# ROBBINS PARK HOTEL

# CONDITIONAL REZONING PLAN

# RZ-100

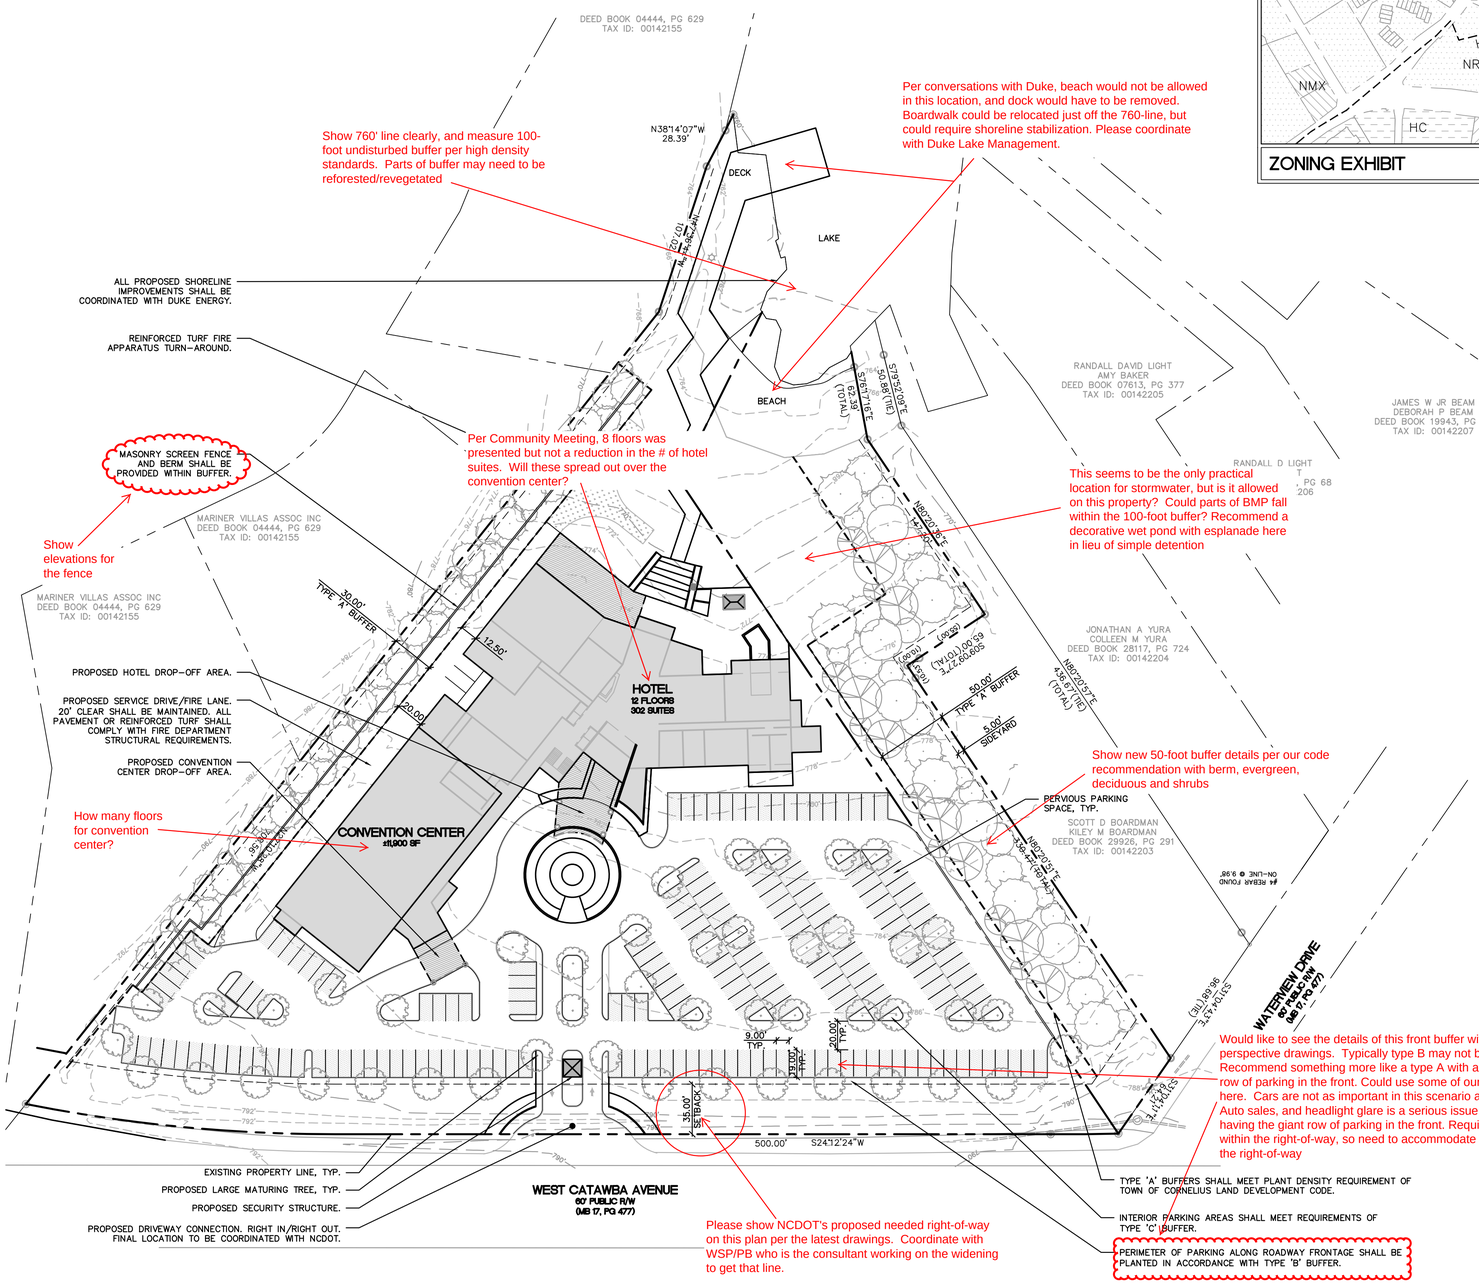
Show 760' line clearly, and measure 100-foot undisturbed buffer per high density standards. Parts of buffer may need to be reforested/revegetated

Per conversations with Duke, beach would not be allowed in this location, and dock would have to be removed. Boardwalk could be relocated just off the 760-line, but could require shoreline stabilization. Please coordinate with Duke Lake Management.

Per Community Meeting, 8 floors was presented but not a reduction in the # of hotel suites. Will these spread out over the convention center?

This seems to be the only practical location for stormwater, but is it allowed on this property? Could parts of BMP fall within the 100-foot buffer? Recommend a decorative wet pond with esplanade here in lieu of simple detention

Show elevations for the fence

How many floors for convention center?

Show new 50-foot buffer details per our code recommendation with berm, evergreen, deciduous and shrubs

Would like to see the details of this front buffer with elevations and perspective drawings. Typically type B may not be enough. Recommend something more like a type A with a berm to screen the row of parking in the front. Could use some of our new proposed buffers here. Cars are not as important in this scenario as they would be for Auto sales, and headlight glare is a serious issue. May consider not having the giant row of parking in the front. Required buffer CANNOT be within the right-of-way, so need to accommodate 20 to 30-feet outside of the right-of-way

Please show NCDOT's proposed needed right-of-way on this plan per the latest drawings. Coordinate with WSP/PB who is the consultant working on the widening to get that line.

This is a building setback. Must be 25' from new ROW

100' from 760' contour

What standard is used for this?
